**SUBJECT:** NuScale Power, LLC Supplemental Response to NRC Request for Additional Information No. 26 (eRAI No. 8840) on the NuScale Design Certification Application

NuScale Supplemental Response to NRC Request for Additional Information eRAI No. 8840

**NRC Question No.:** 19-2

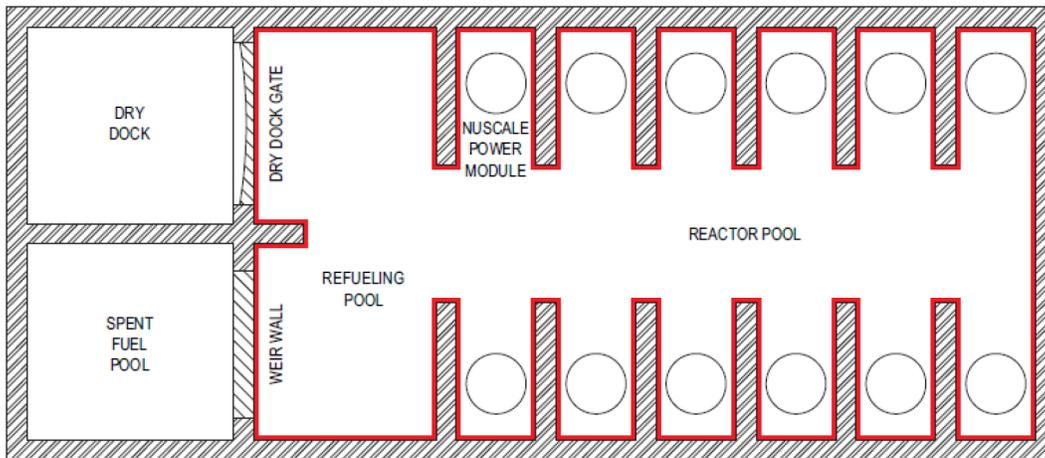
To allow the staff to evaluate the Level 1 model and assumptions related to the containment isolation function, the staff requests the applicant to explain how the containment isolation

function can be guaranteed to succeed in the Level 1 accident sequences. In your response, please provide the following:

- a. Identify the potential scenarios (combinations of pathways, equipment failures and human failure events) that could lead to coolant inventory loss from the reactor pressure vessel to outside of the containment vessel.

- b. For the scenarios identified in a), explain how the containment isolation function is accounted for in the Level 1 model, if this function is necessary to support any key safety functions (e.g., passive safety functions).

- c. For the scenarios identified in a), if the containment isolation function is not necessary to support any key safety functions, please describe any relevant analyses used to support this conclusion. Describe any uncertainty analyses performed for these supporting analyses.

surrounding structures. In the NRELAP5 model, the UHS consists of the twelve module bays, the center channel, and the refueling pool, and is modeled as a well-mixed, bulk volume. The spent fuel pool (SFP) fluid volume and heat load are not included as part of the modeled UHS because of variable SFP heat loading, limited mixing with the rest of the pool, and because it is a net heat sink in some situations (that is, it is conservative to not include the combined SFP volume and heat load). A simplified schematic outlines the modeled UHS pool volume in the following figure.

In the “base” case simulation, a single NPM deposits heat into the modeled pool volume. A “limiting” case was also evaluated using the modeled pool volume divided by twelve (i.e., corresponding to one module bay and 1/12th of the central channel and refueling pool volumes). The limiting case results in the bulk UHS pool temperature increasing twelve times faster than the base case and approximates twelve NPMs depositing their decay heat load into the full pool. Even with this more challenging condition, the liquid level remains well above the core for the duration of the 72-hour mission time.
